Revised TMJ Product Change Notice
for 9.0-inch WVGA NL8048BC24-09 and -09D
PCN Tracking Number: TMJ-PP-0187
(Previous PCN NLT-PP-6457)

TMJ-PP-0187

6. Product revision

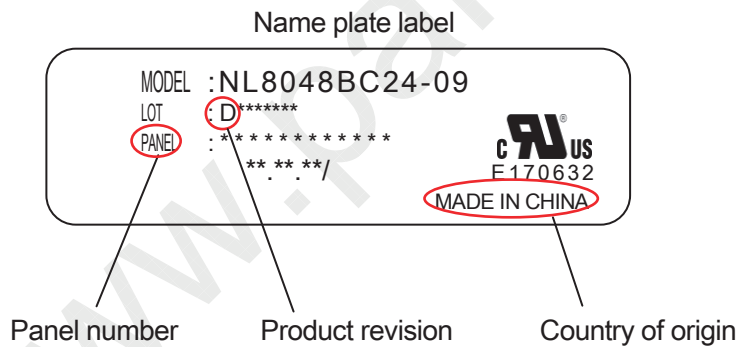
Type name	Current Akita products	PCN NLT-PP-6457 (Cancellation of PCN)	After change PCN TMJ-PP-0187 (This document)
NL8048BC24-09	B	C	D
NL8048BC24-09D	B	C	D

8. Internal control label and marking-off lines

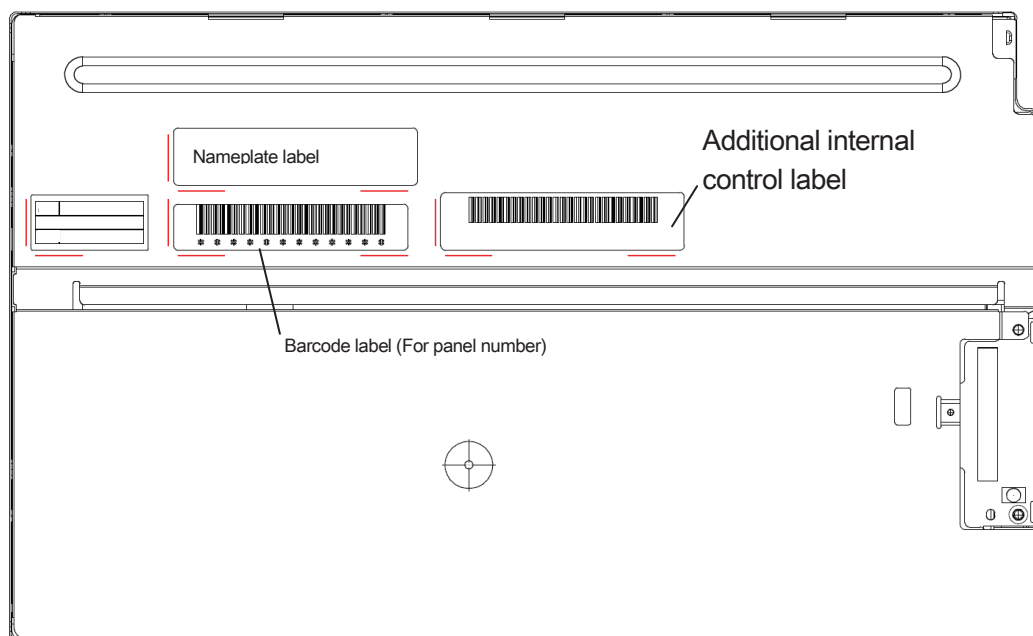
Item	Current Akita product	PCN NLT-PP-6457 (Cancellation of PCN)	After change PCN TMJ-PP-0187 (This document)
Signal processing board	Current	←	←
Timing controller IC	Current	←	←
Driver IC (Horizontal IC and vertical IC)	Current	←	←
FPC for TFT panel	Current	←	←
Backlight	Current	←	←
Metal chassis	Current	← (Marking-off lines for reference of label attachment position will be added on the back side of the product.)	←
Nameplate label	<ul style="list-style-type: none"> Country of origin: MADE IN JAPAN Panel number: The number of digits: 13 	<ul style="list-style-type: none"> Country of origin: MADE IN CHINA Panel number: The number of digits: 12 	←
Additional internal control label	-	Addition	←

— Marking-off line
